bldc2018-00130

**Revised Window Schedule 6.27.18.pdf**
161K

**08500-001 Muntin Profiles.pdf**
211K

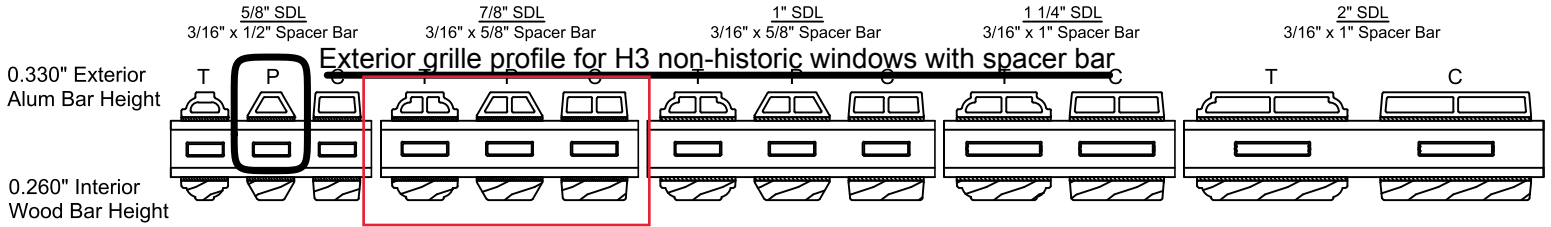
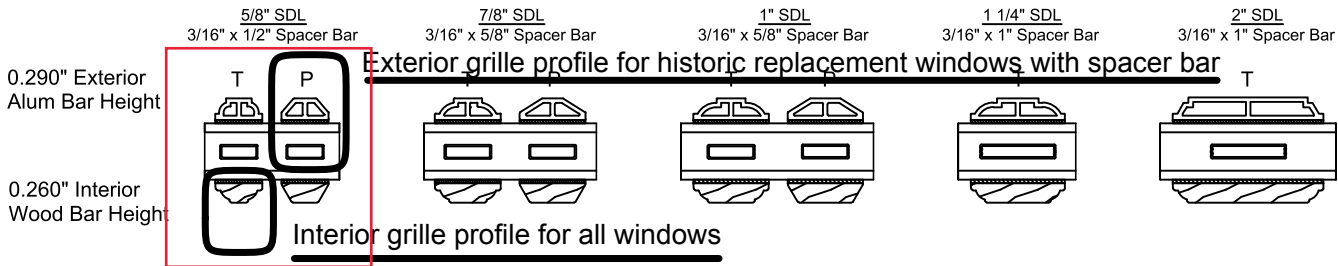
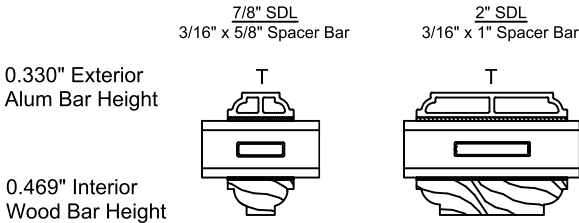
1) Our understanding is that the H3 windows will have applied SDL's. Muntins on these windows should be 7/8". (Muntins on historic building to be 5/8".) **Attached is the Sierra Pacific Muntin Chart. I have put a red box around the 7/8" options for the H3's (there are 3 choices) and also around the 5/8" options for the Historic Replicas (There are 2 Choices). Please clearly identify which muntin profile you would like to see on each window.**

Thanks for the quick response. On the basis of the additional information provided, we are comfortable approving the windows as described. Note that the 7/8" muntins in the H3 series windows should have a putty profile.

**08500-001 Muntin Profiles.pdf**
216K

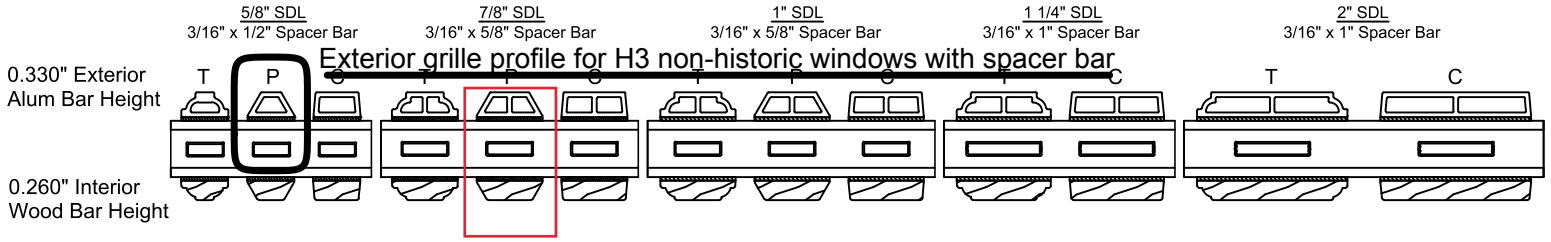
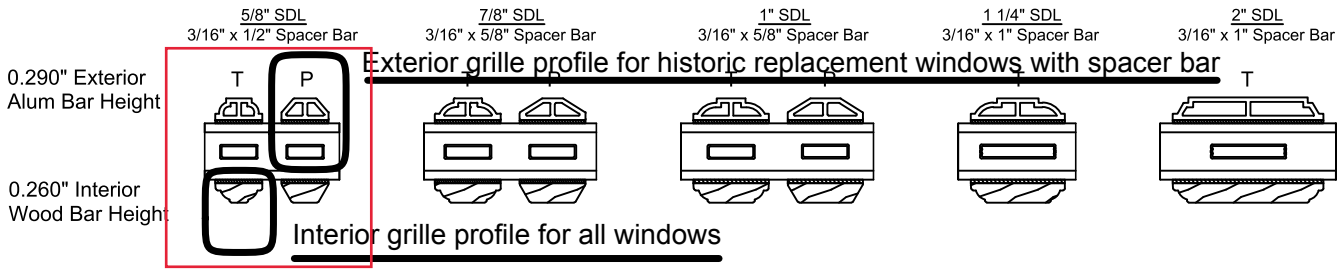
We also appreciate the quick response. Can you please confirm the profiles we have boxed around are what you will approve?
